Pre-lodgement Meeting Notes

Application No:	PLM2024/0043
Meeting Date:	16 July 2024
Property Address:	2 Sydenham Road BROOKVALE
Proposal:	Proposed light industrial development with ground floor café and basement parking
Attendees for Council:	Clare Costanzo, Planner Alex Keller, Principal Planner James Brocklebank, Traffic Engineering Coordinator

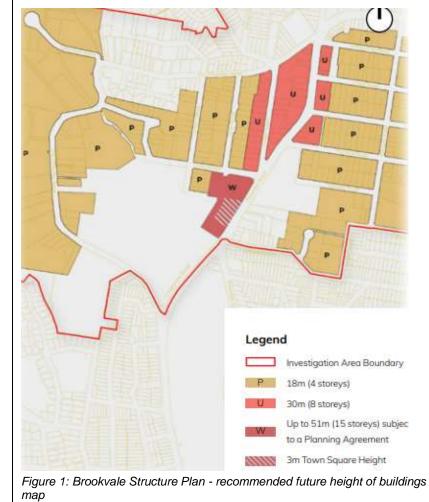
The proposed building height significantly exceeds the current building height control for the site. However, the Brookvale Structure Plan has been endorsed by Council and the recommended future height of buildings map for the site indicates a building height of up to 18m (four storeys) – see Figure 1 below.

Council has concerns the proposed building height in conjunction with the limited setbacks to both Sydenham Road and Charlton Lane will not satisfy the objectives of the LEP specifically regarding the visual impact of the building.

Council recommends increasing the setbacks to Sydenham Road (4.5m all levels) and Charlton Lane (façade articulation (<0.5m) or consistent 4.5m with fenestration) and to provide for further articulation to higher storeys and reduce the visual impact of the building. This is particularly important given its prominent corner location within close proximity to Pittwater Road and future shop top housing. Council will not support the undesirable precedent submitted at the PLM given that this is likely to
